FINAL DRAINAGE PLAN

LORSON RANCH EAST FILING NO. 1

MARCH 1, 2018

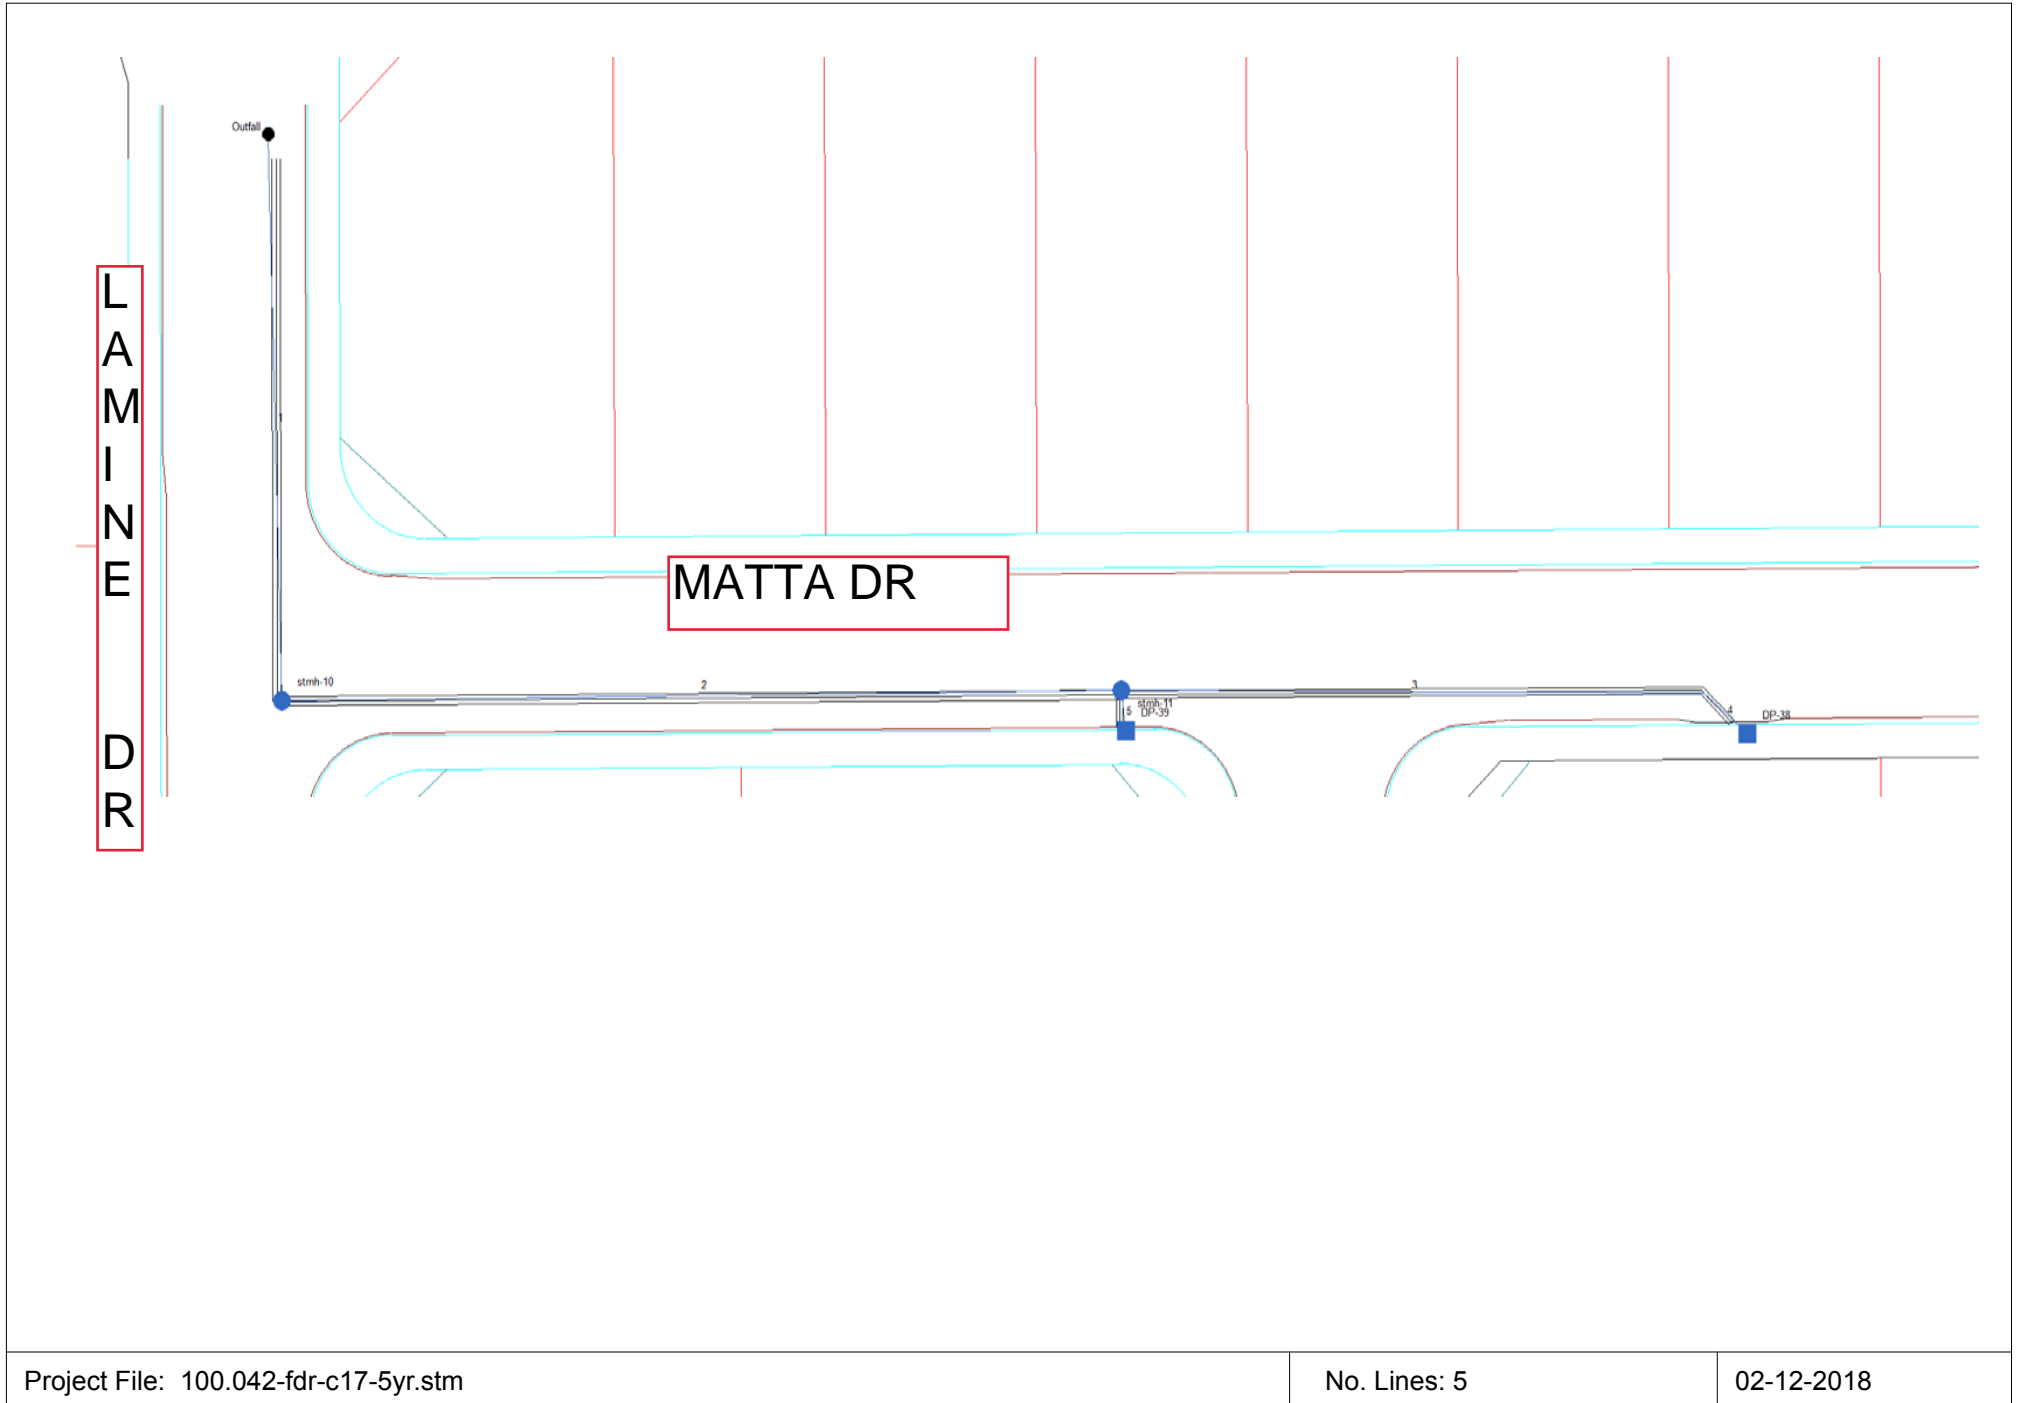
Provide for all storm systems serving Filing No. 1, including interim conditions accommodating offsite flows.

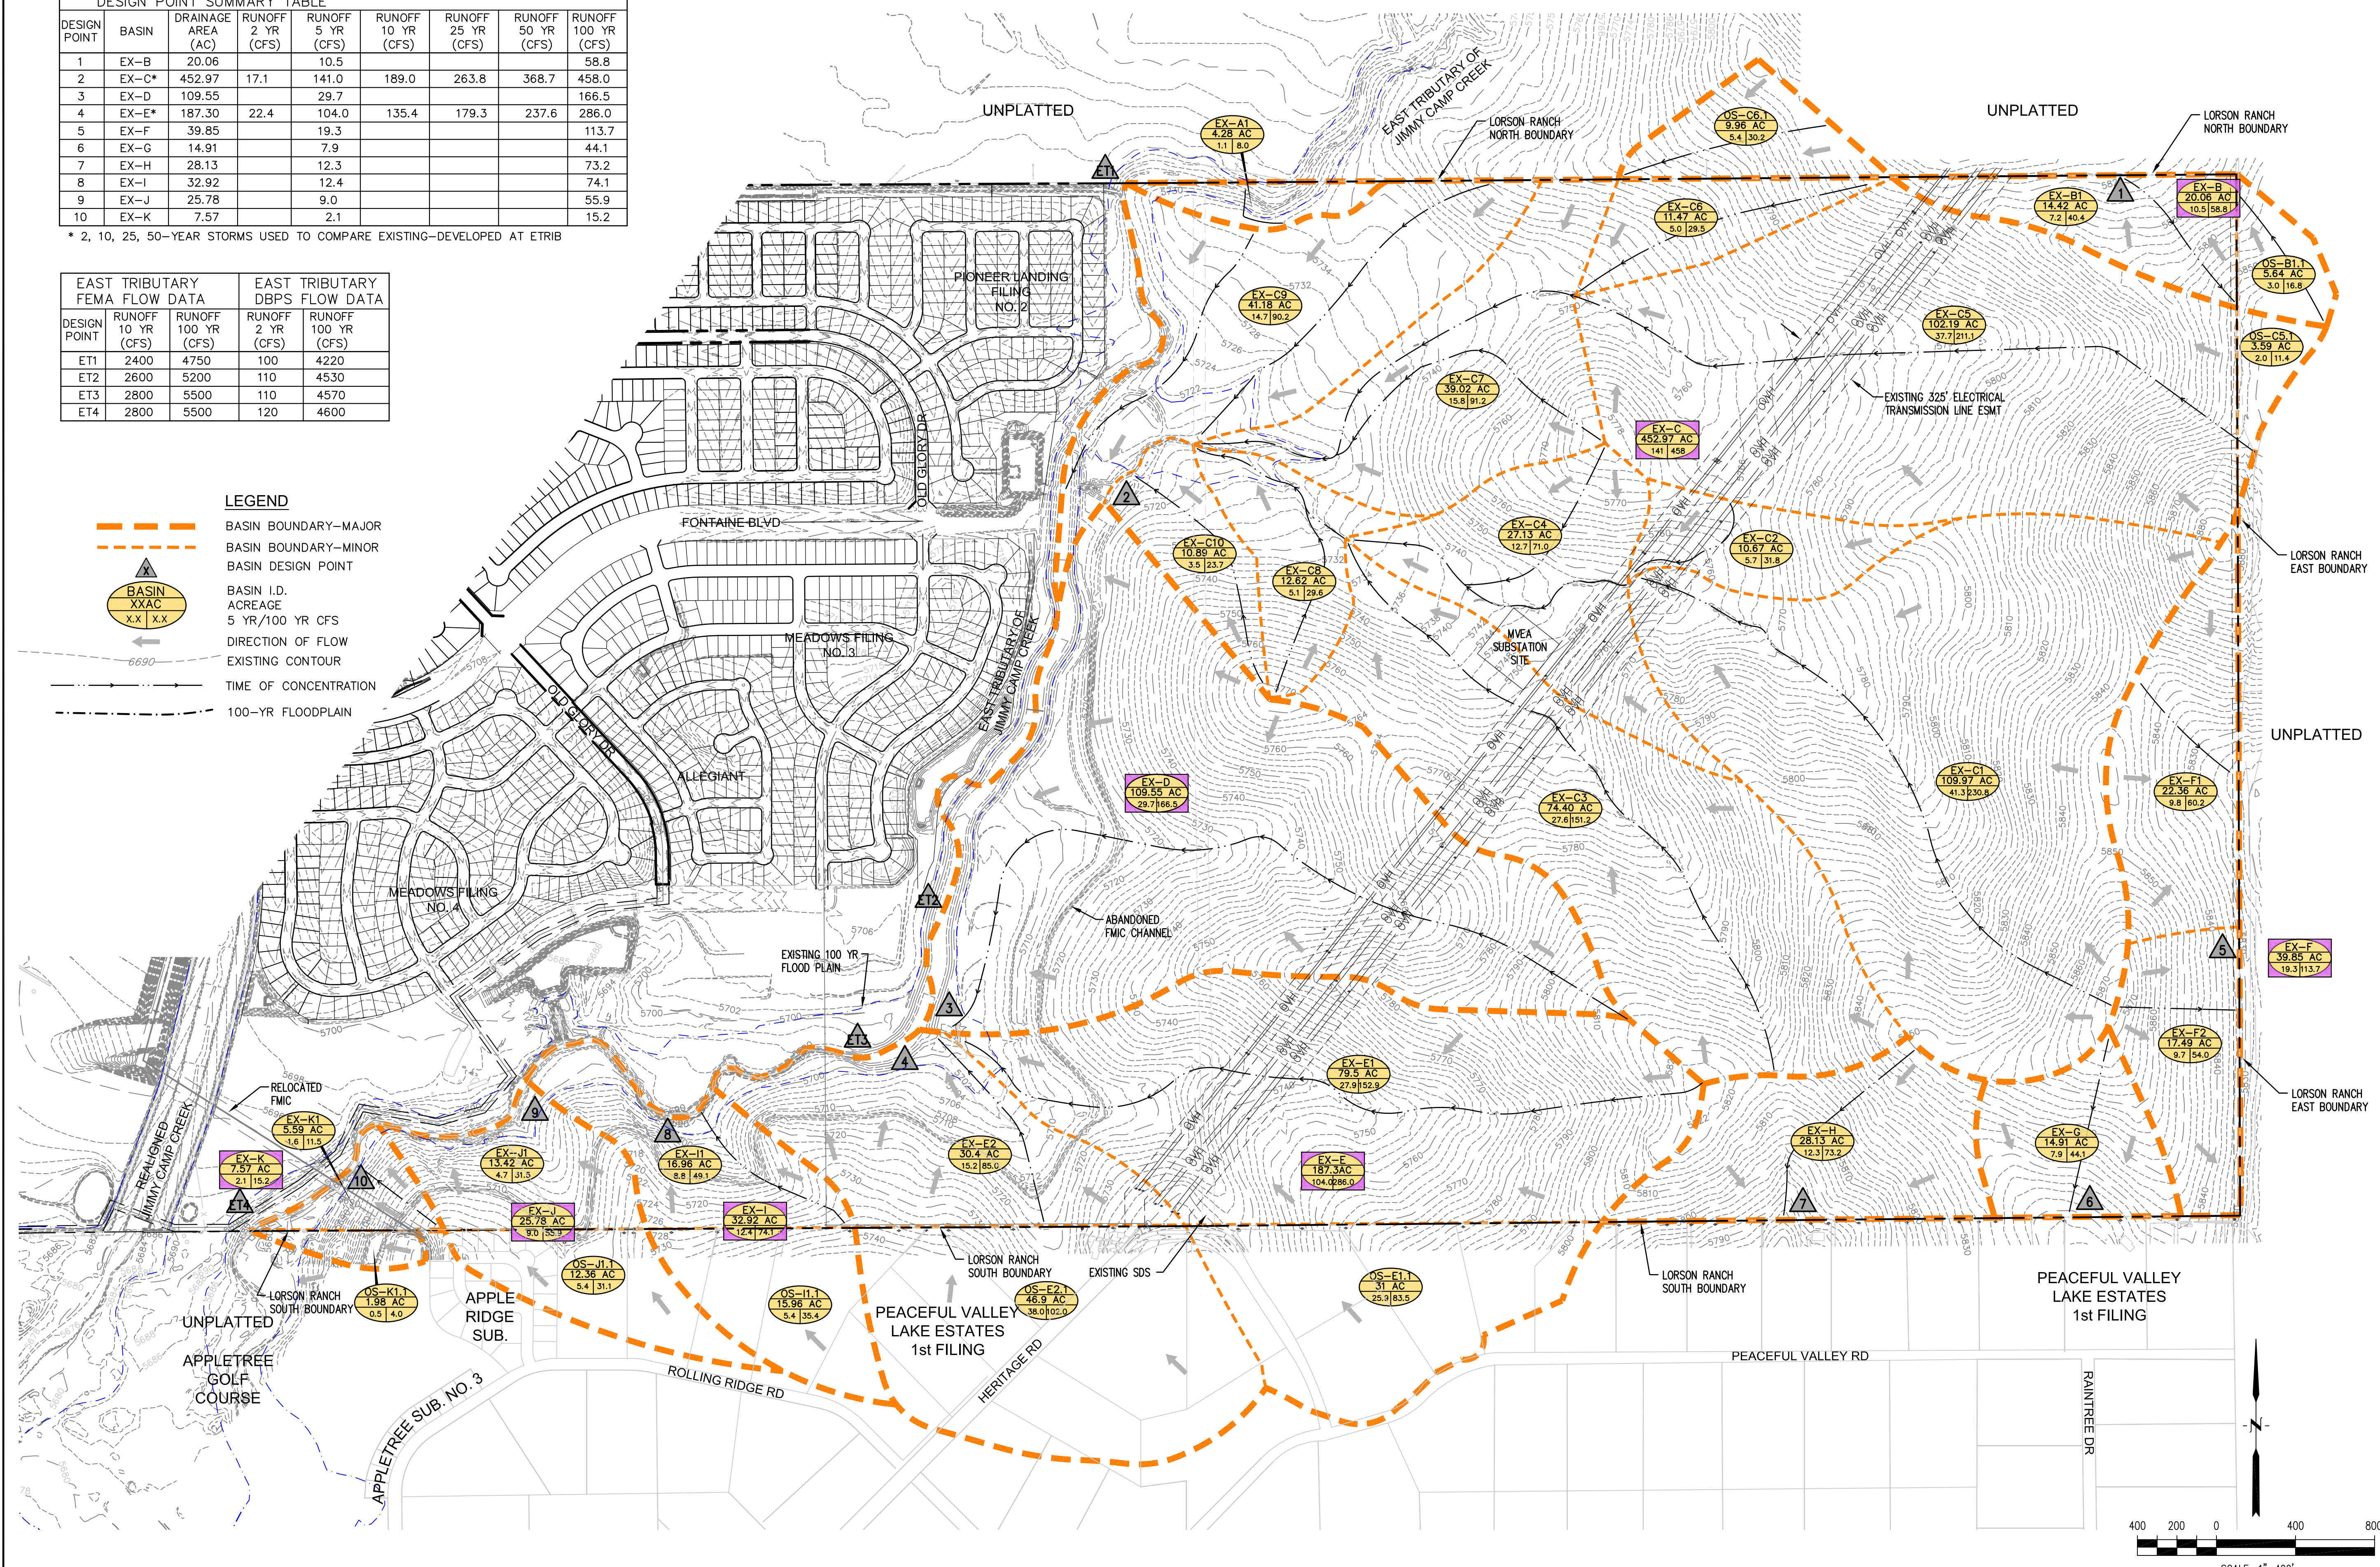
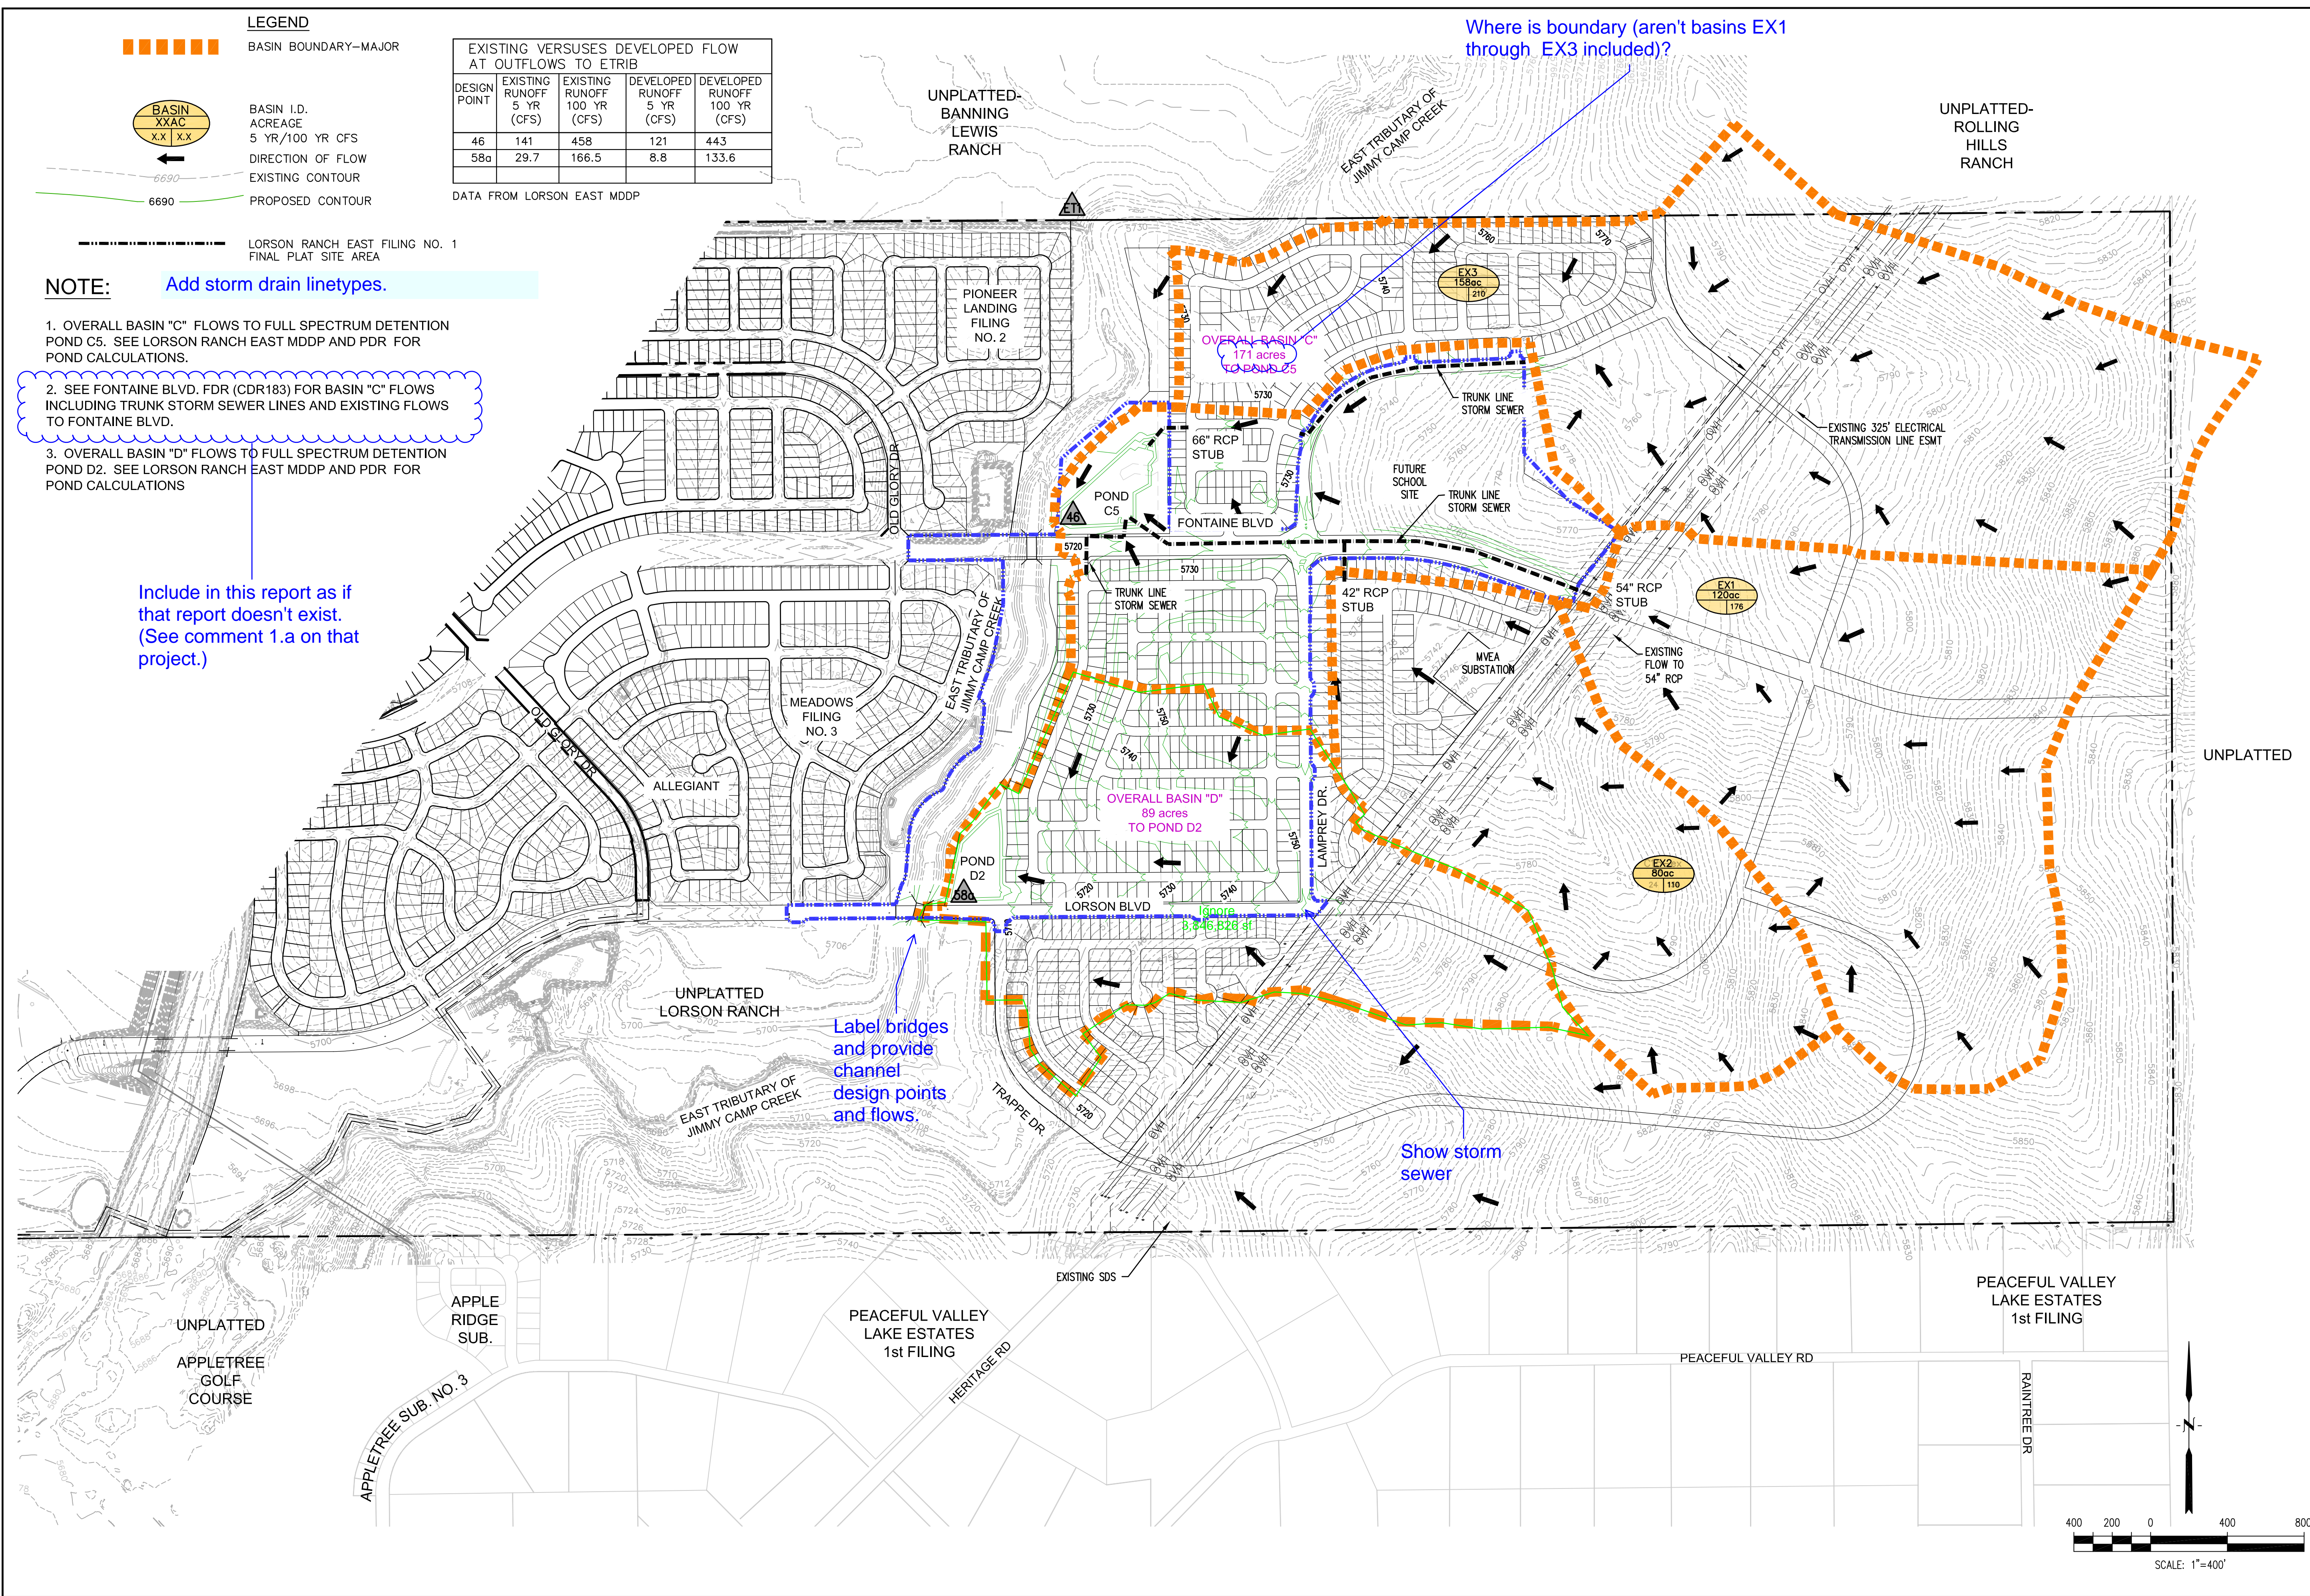
NOTE: Add storm drain linetypes.

Include in this report as if that report doesn't exist. (See comment 1.a on that project.)

Label bridges and provide channel design points and flows.

Show storm sewer
